# 802.3dj D2.2

## Comment Resolution

### Electrical Track

Figure 179A-3— Channel Min (TP0d-TP5d) at 53.125 GHz

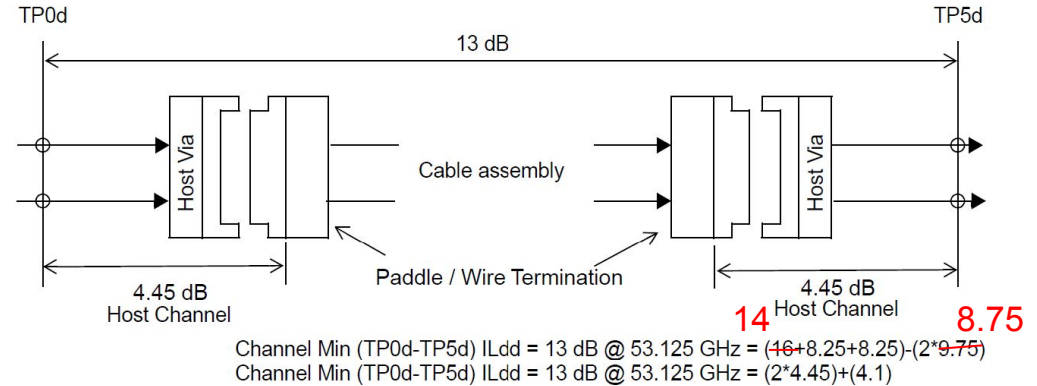
In D2P2, we do not have any tests for  $ILdd_{Ch,min}$ . In past projects, the minimum Host has been defined as the MCB, but that is not the case with 3dj.

The resolution for Comment #232 would changed the host channel allocation from 4.45 dB to 3.45 dB.

It is suggested to keep that value as 4.45 dB and instead make  $ILdd_{CA,min}$  14dB, as shown on the right.

Editor's recommendation: AIP (since no new data is presented) ;  
Change  $ILdd_{CA,min}$  to 14dB, and change appropriate values in 179, and 179A.  
Implement with editorial license

Figure 110–3b—Test channel calibration

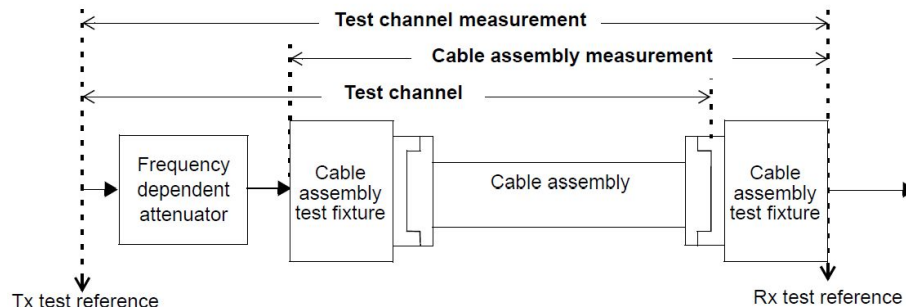
There are some ripple effects to this change, related to receiver tolerance testing.

The current tests in Table 179-14 do not really test HL, HN, and HH, but rather CA-B, CA-C, and CA-D.

The details of refining Table 179-14 are beyond the scope of the comment, and changes would be deferred to a future draft.

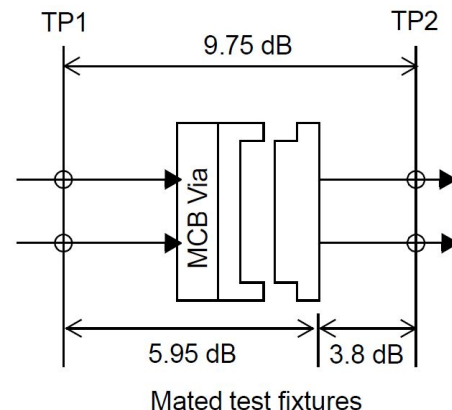
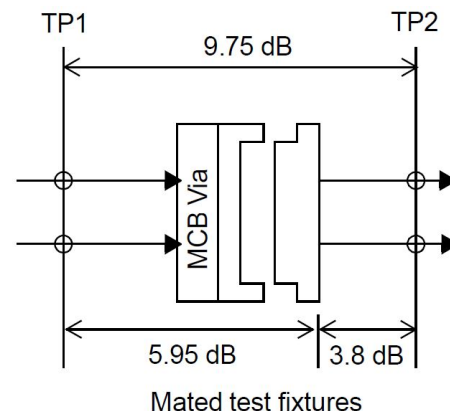
For the TP2/TP3 test fixture, the reference point is defined to be the "center of the edge connector pad". In 179B.3.1, it is stated that the reference point for the cable assembly test fixture is the "mating point of the MDI connector". There is a note in 179B.4.2 that states the reference insertion loss for the mated test fixture is the sum of the reference insertion losses for the TP2/TP3 test fixture and cable assembly test fixture. This suggests that the "center of the edge connector pad" and the "center of the edge connector pad" are the same reference point. If this is the case, then the same name/description should be used in both instances.

Call the reference point either "center of the edge connector pad" or "mating point of the MDI connector" consistently in both 179B.2.1 and 179B.3.1. Consider adding a note to Figure 179A-1 to describe the this reference point since the illustrations do not clearly show it.

The commenter points out a nomenclature conflict that must be remedied. The use of "mating point of the MDI connector" is most appropriate to apply to both instances. For completeness, the editorial team will prepare a detailed proposed response for the CRG to review.

Change the highlighted text in 179B.2.1 (TP2 or TP3 test fixture) to “mating point of the MDI connector”.

Figure 176D-4—Host compliance points

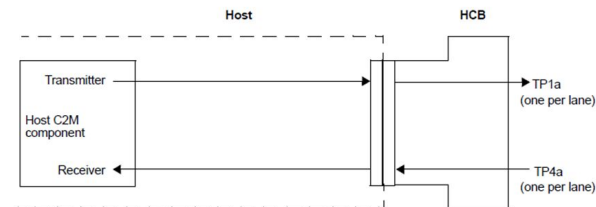
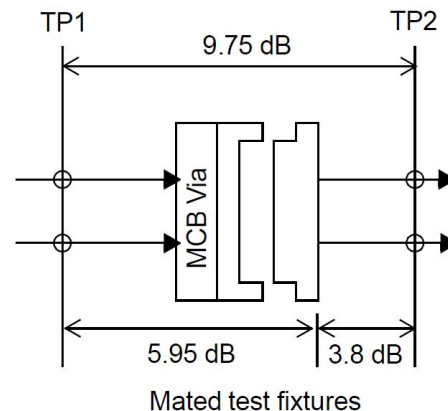
This is the normative clause that defines the TP2 or TP3 test fixtures. The test fixtures assume an MDI connector, a PCB board, and a coaxial connector enabling connection to test equipment, but that is not stated anywhere.

"Transmitter and receiver measurements at TP2 or TP3 for the 200GBASE-CR1, 400GBASE-CR2, 800GBASE-CR4, and 1.6TBASE-CR8 hosts (see Annex 179D) and at TP1a or TP4a (see Figure 176D-4) for the 200GAUI-1, 400GAUI-2, 800GAUI-4, and 1.6TAUI-8 C2M hosts (see Annex 176D), are made utilizing test fixtures. Each such test fixture has an edge connector plug that is compatible with the MDI receptacle on the host board, a coaxial connector for each lane suitable for connection to test equipment, and a PCB connecting the lanes from the edge connector plug to the coaxial connectors. The test fixture reference insertion loss is specified in 179B.2."

**Editor's recommendation: Change the text in 179B.2 as shown below.**

The TP2 or TP3 test fixture (also known as Host Compliance Board) is required for measuring the transmitter and receiver specifications at TP2 and TP3. The test fixture has an edge connector interface that is compatible with the appropriate MDI connector on the Host board, and provides a high-speed electrical path between the MDI connector and the coaxial connector that defines the TP2 or TP3 test point. The TP2 and TP3 test points are illustrated in Figure 179A-1.

The TP2 or TP3 test fixture is also used in AUI-C2M testing for host input and output compliance. The TP2 and TP3 test points correspond to the Annex 176D test points TP1a and TP4a, respectively. The TP1a and TP4a test points are illustrated in Figure 176D-4.

Figure 176D-5—Module compliance points

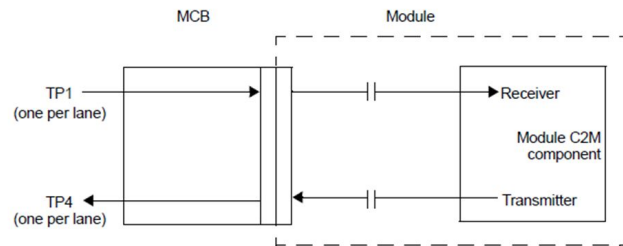
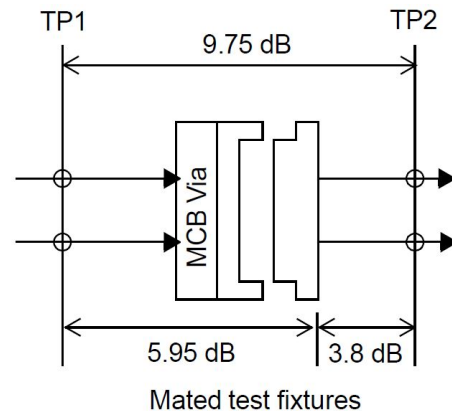
This is the normative clause that defines the Cable test fixtures. The test fixtures assume an MDI connector, a PCB board, and a coaxial connector enabling connection to test equipment, but that is not stated anywhere.

"Cable assembly measurements for the cable assembly types (see Annex 179D) are made between TP1 and TP4 with cable assembly test fixtures at both ends. Each such test fixture has an MDI receptacle compatible with the MDI plug at the end of the cable assembly, a coaxial connector for each lane suitable for connection to test equipment, and a PCB connecting the lanes from the MDI receptacle to the coaxial connectors. The test fixture reference insertion loss is specified in 179B.3. The TP2 or TP3 test fixture and the cable assembly test fixture are specified in a mated state to enable connections to measurement equipment. The reference insertion loss of the mated test fixtures is 9.75 dB at 53.125 GHz using Equation (179B-5)."

**Editor's recommendation: Change the text in 179B.3 as shown below.**

The cable assembly test fixture (also known as Module Compliance Board) is required for measuring the cable assembly specifications in 179.11 and the module specifications in Annex 176D at TP1 and TP4. The test fixture has an MDI connector, and provides a high-speed electrical path between the MDI connector and the coaxial connector that defines the TP1 or TP4 test point. The TP1 and TP4 test points are illustrated in Figure 179-2.

The cable assembly test fixture is also used in AUI-C2M testing for module input and output compliance. The TP1 and TP4 test points for AUI-C2M testing are illustrated in Figure 176D-5.
